Oldland Mill, Keymer, Sussex.

Report on Condition, and Suggestions for Repair 12th July 1980.

Sketches 1 & 2 - Temporary support for windshaft:

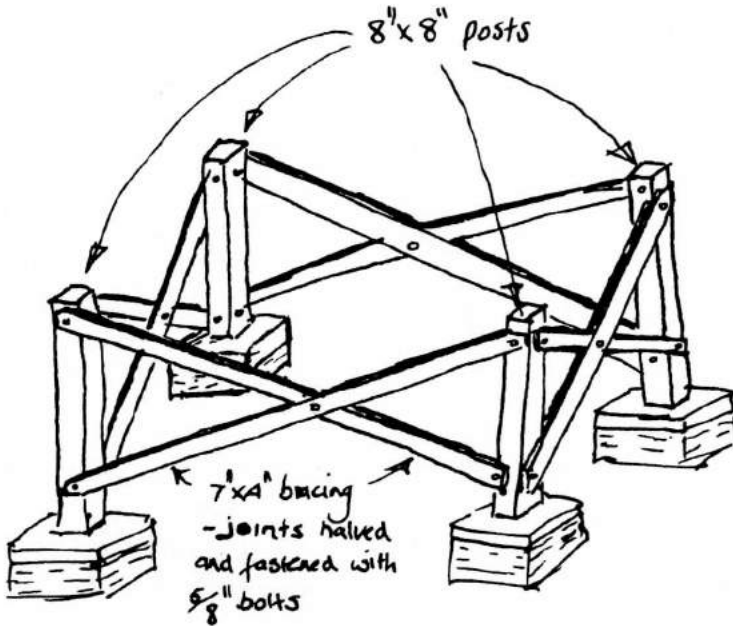
1) The weather- or breast beam which carries the windshaft and sweeps is very rotten, and the cast-iron chair which bears the neck brass is sinking in and tilting to the left. If this is not dealt with soon, the windshaft and sweeps may overbalance and crash down through the Mill, causing severe damage and collapse. It is suggested that a spreading beam is bolted down to the weather beam behind the neck bearing to spread the weight, and a dummy wooden bearing bolted to it to carry the windshaft, but allowing the rotation of the sweeps during their removal. In addition, a block of wood should be bolted to the prick-post to support the back of the weather beam which will now be taking some of the weight. See sketches 1 and 2.

Sketch 3 - Timber shoring under main corner posts

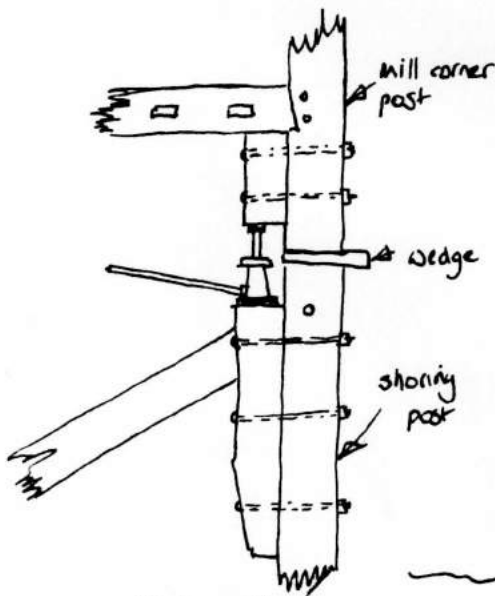
Whilst steel shoring has been suggested, my own preference is for wooden shoring, which looks much less ugly than steel, and is easier to modify and adapt on site with normal tools. In addition it is easier to attach a flashing where a post or brace passes through the roundhouse roof. I would suggest four props, one under each of the four main corner posts as before, but cross-braced to withstand wind pressure. The bracing will have to be placed where space permits, avoiding the trestle timbers. See sketch 3.

Sketch 4 - Detail of jacking arrangement.

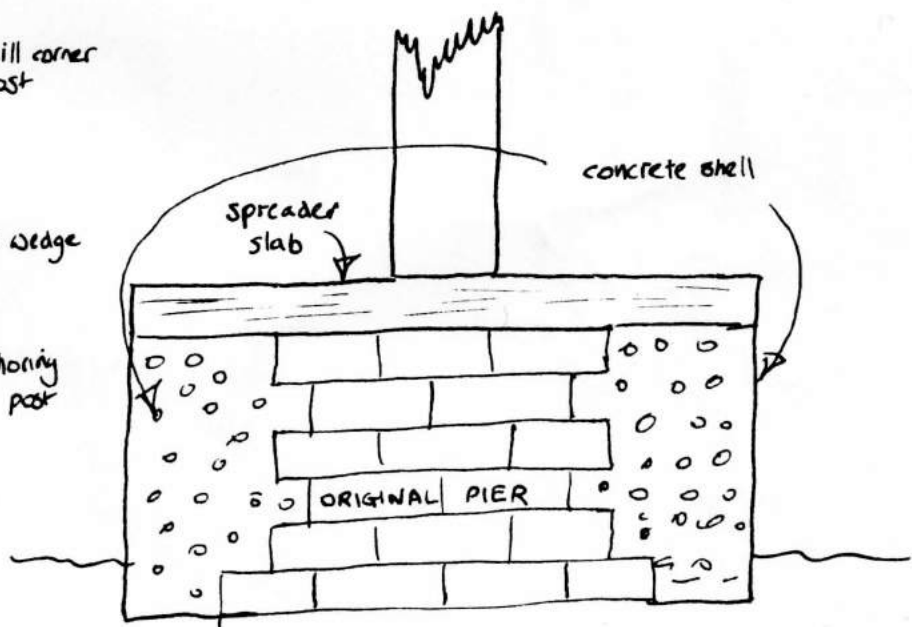
Wooden blocks may be bolted to the sides of the shoring posts at the top to facilitate jacking-up to tighten the props with wedges. Later they could be used to level the Mill. See sketch 4.

Sketch 5 - Detail of shoring post pier.

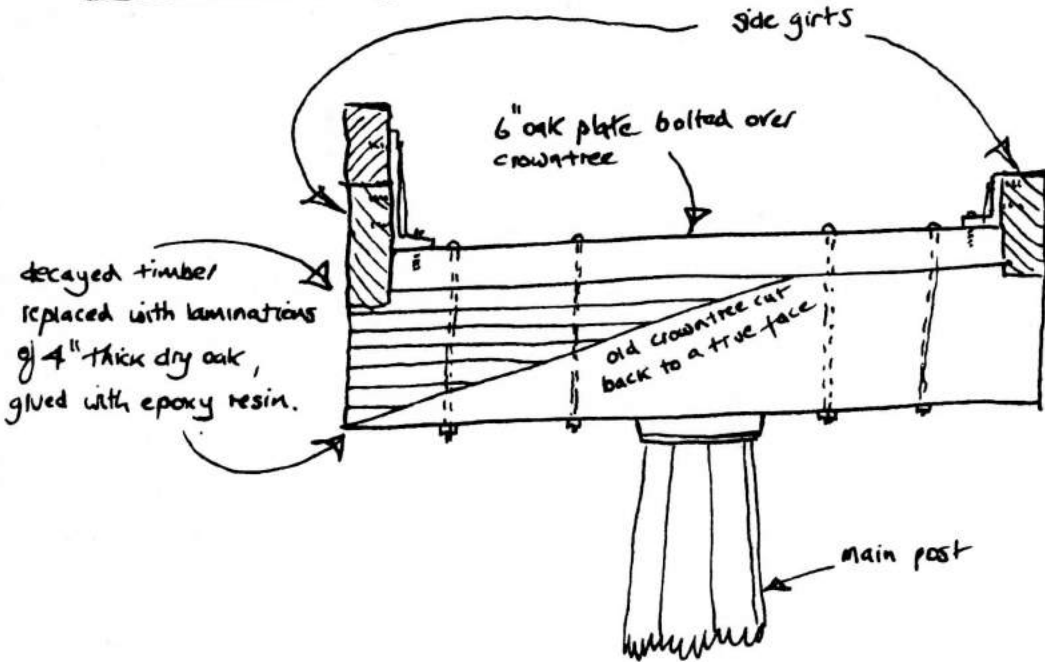
The original posts have rotted inside their brick casings. The piers supporting them are rather small, and could be increased in size by casting concrete shells around them. The new posts should be footed on 4" thick timber slabs on top of the piers to spread the weight. See sketch 5.

Sketch 6 - Suggested Repair to Crowtree

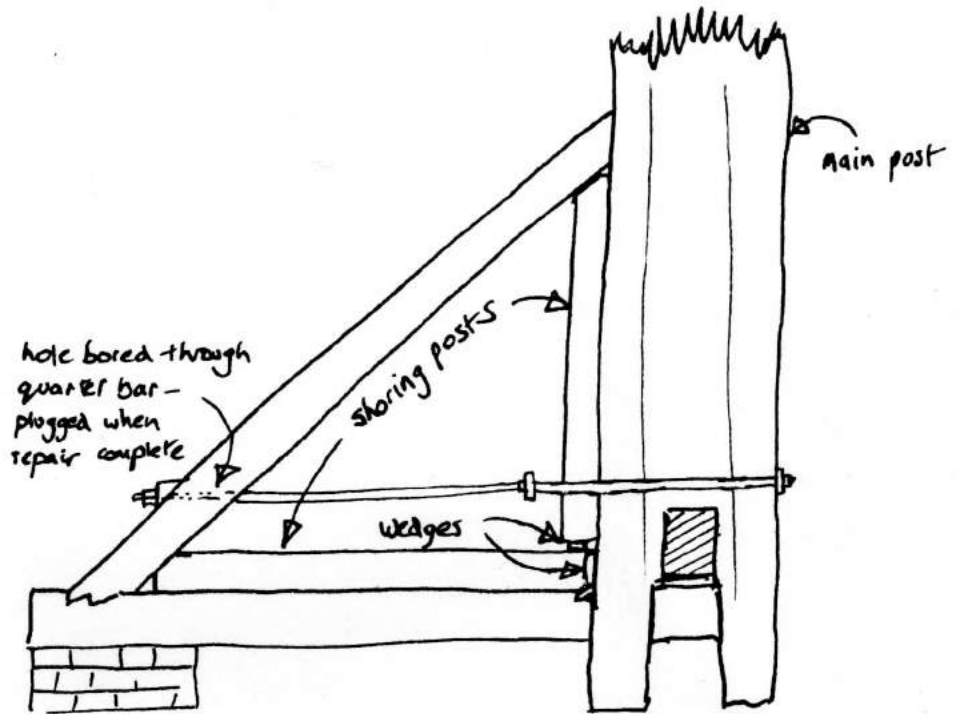
The crowntree is very badly worm-eaten on the left-hand side from the joint with the sidegirt almost to the centre. It has moved approx. 4" upwards in relation to the left sidegirt. I think the best way to deal with this is to cut away the beam by chainsawing, cross-cutting and splitting off, electric planing etc. back to an inclined true face, and to shape new timber to fit. This may be in the form of laminations glued with epoxy resin to avoid handling a large heavy timber. A 6" thick oak plate should be installed above, and the whole assembly bolted together. See sketch 6.

Sketch 7 - Suggested Method of securing trestle joints while under repair.

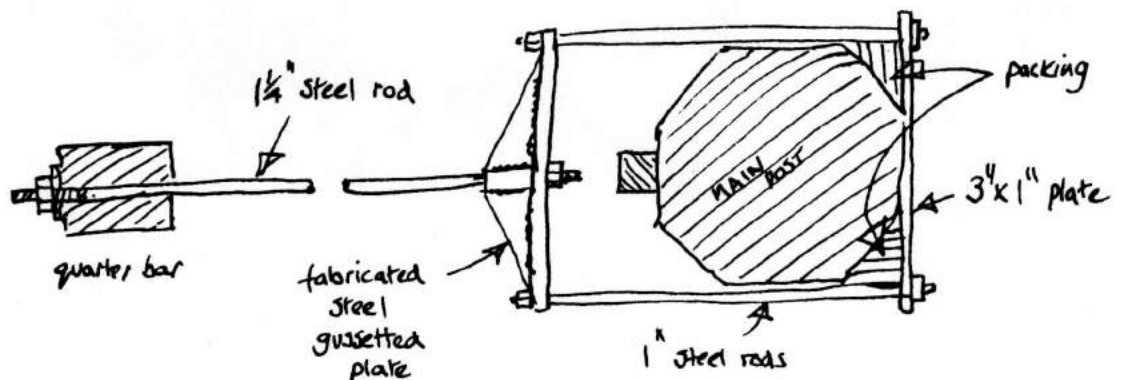
As far as repair is concerned, the ideal solution would be to renew the crosstrees and quarter bars as was done at Nutley Mill by volunteers. An alternative would be to add "cheek pieces" to the crosstree-quarter bar joints, as suggested by Mr. Gregory. Where these already exist, but are in poor condition, it would be necessary to remove the originals first. Extra temporary reinforcement would be essential when this was being done. See sketch 7.
